Access Compliance Report Public Rights-of-Way (Pedestrian Signals)

Main Street: **HOLT_AVE** Cross Street: **17TH_ST** Location: **SW**

ADA ID: **SGRK211007150224** Signal Type: **One Push Button-APS** Overall Compliance: **No** Severity Scores: **BTN 1: 25** **BTN 2: N/A** **No BTN: N/A**

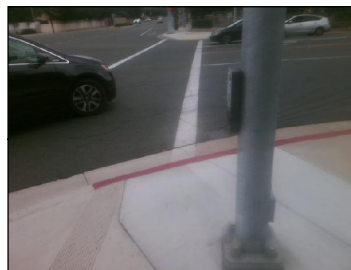
OC Std/PROW: **R404.2, R404.3**

Possible Solutions: Remove and Replace Clear Space.
